**REQUEST FOR INFORMATION (RFI)**

PROJECT :	BKK2	R.F.I. NO. :	523213-01-RFI-EL-0002
TO :	CTA	ATTENTION :	CTA
SUBMITTED DATE:	15-Jan-26	NEED REPLY BY DATE :	22-Jan-26

SUBJECT : Request for Information - Pre-Action System for Comm Riser 1st FL

Refer. Drawing :  
523213-02-DRG-FI-0016, 523213-02-DRG-FI-0201  
523213-02-DRG-EL-0700

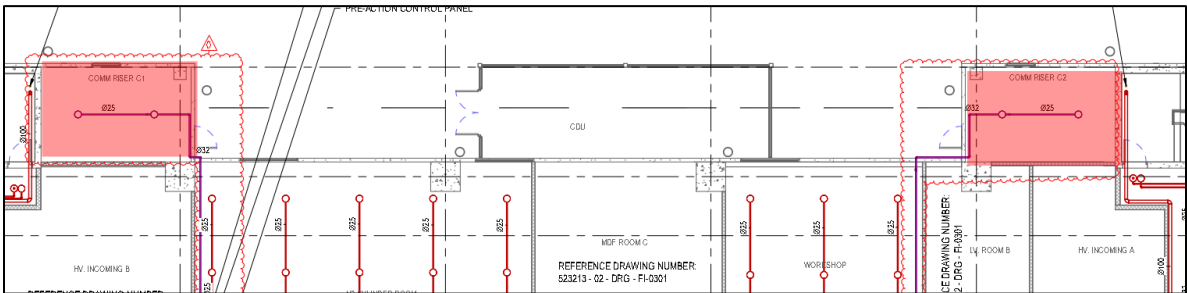
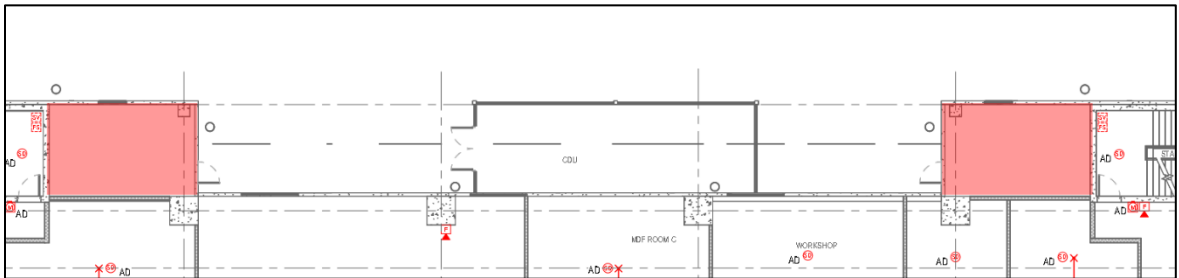
According to the Fire Protection drawing, A dry pipe of Pre-action system is provided at the Comm Riser area (1st floor) and required to interface with Fire Alarm System.

However, No fire alarm detector is shown in this area on the fire alarm drawings. Kindly confirm whether a detector is required to be added at the Comm riser area for

Pre-action system operation.

Description :  
Based on the fire protection drawings, the dry pipe at the Comm riser area is designed to function as pre-action system with interface to the fire alarm system. However, the fire alarm system do not indicate any detector within this area. We would appreciate your clarification on whether additional detectors shall be provided to enable the pre-action interface.

AUR :  
Based on the design information for this area, it is a communication riser with a continuous void opening from Level 1 to Level 5, without floor slabs at each level. Accordingly, AUR has provided a smoke detector at the top of the void (Level 5).

Note :  
The Contractor shall ensure that the construction follows this design concept.  
- If floor slabs are provided at each level, please proceed to install an additional smoke detector at Level 1.  
- If the construction follows the original design concept (continuous void), please refer to Drawing EL-0704 and install additional smoke detectors for each riser to be consistent with the pre-action system requirements.
